COUNCIL ASSESSMENT REPORT

Panel Reference	2018SNH044
DA Number	173/18
LGA	North Sydney
Proposed Development	Alterations and additions to a commercial building
Street Address	73 Miller Street, North Sydney
Applicant/Owner	Colliers International Project Management Pty Ltd
Date of DA lodgement	8 June 2018
Number of Submissions	Nil
Recommendation	Approval
Regional Development Criteria (Schedule 7 of the SEPP (State and Regional Development) 2011	Capital Investment Value (CIV) of greater than \$30 million
List of all relevant s4.15(1)(a) matters	North Sydney LEP 2013 • Zoning – B3 Commercial SEPP 55 – Contaminated Lands SREP (Sydney Harbour Catchments) 2005 North Sydney DCP 2013
List all documents submitted with this report for the Panel's consideration	• Conditions • plans
Report prepared by	Lara Huckstepp, Executive Planner
Report date	29 February 2019

Setback along eastern elevation, between Blue Street and Gas Line which provides a high level of public access

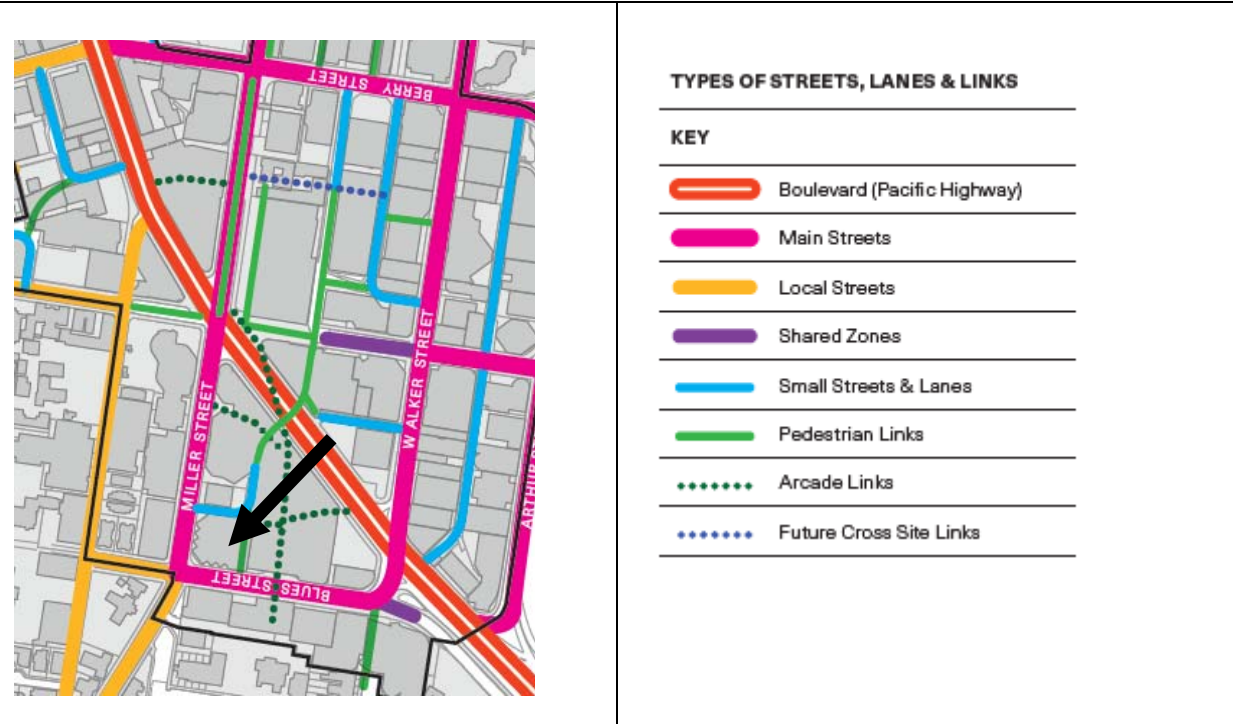
The setback to the eastern boundary provides an important pedestrian connection between Gas Lane / Greenwood Hotel and Miller Street, and further to North Sydney Station. This setback is currently subject to a 1.5m drainage easement in favour of Council and is required as an overland flow path.
